Office Action Summary

10/823,486

HULL, GERRY G.

Fig. 1 – Fig. 2 from Shah (6,595,430)

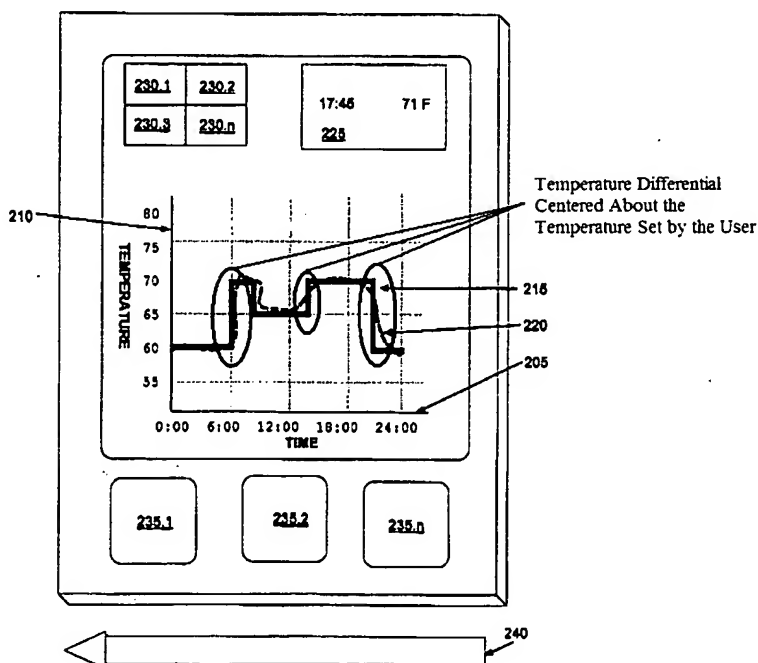
In regard to claims 1 and 18, Shah provides a display where the display is operable to illustrate a range of temperature on the first axis, and a range of times on the second axis (C-4, L-7-10). Referring to Fig. 1, there is also a shaded area defining the temperature differential centered about temperature set by the user.

In regard to claim 2, Shah teaches a step of providing a line indicating the past temperature of at least one area. Referring to Fig. 1, Shah provides a bold line (shaded area) indicating the temperature as 60 degrees between 0:00 and 6:00.

Fig. 2 – Fig. 1 from Ratz et al. (5,203,497)

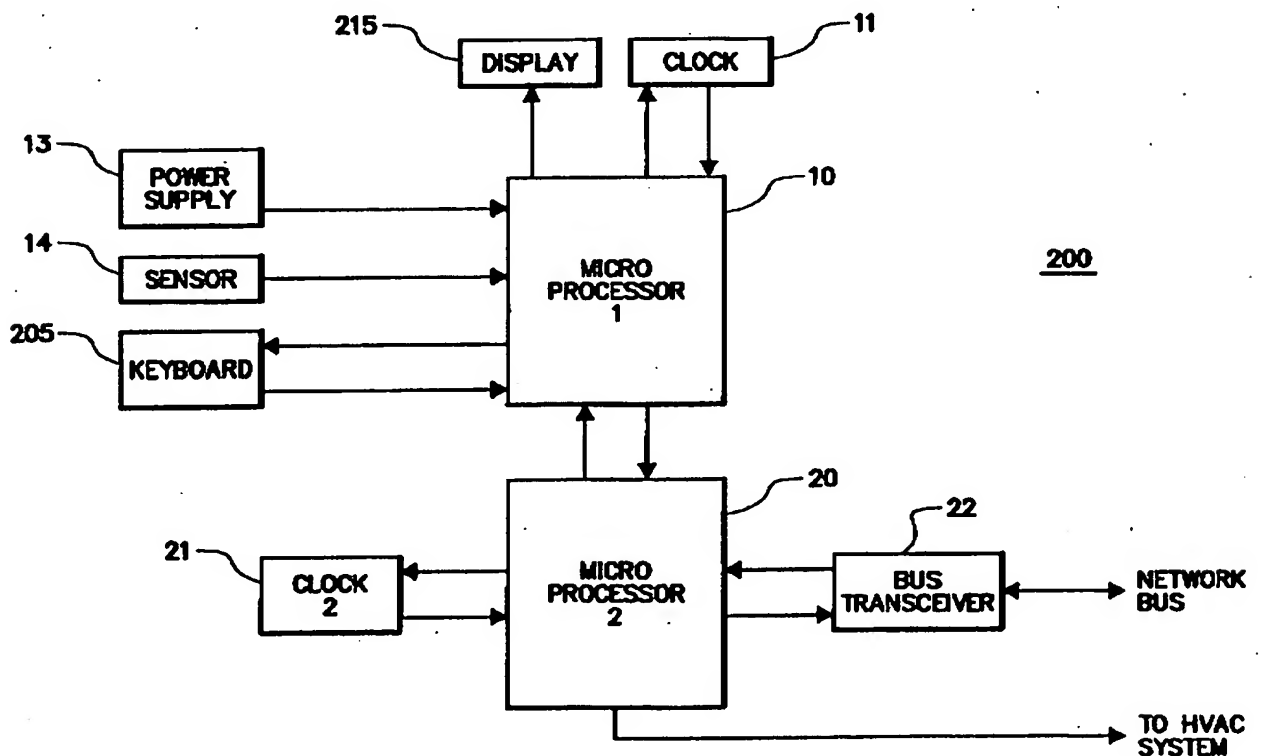
In regard to claim 9, Ratz et al. teach reporting the temperature local to the at least one display to a device located remote from the at least one display (C-2, L-30-32, 57-59). Referring to Fig. 1, one can see that once the temperature is measured it sends signal to microprocessor 1, and microprocessor 1 provides a temperature signal to display (215) and the microprocessor 2. Microprocessor 2 is connected to a HVAC system. Ratz et al. thermostat is on a local area network, therefore it would have been obvious to one having ordinary skill in the art at the time the invention was made to display the temperature at a remote location.
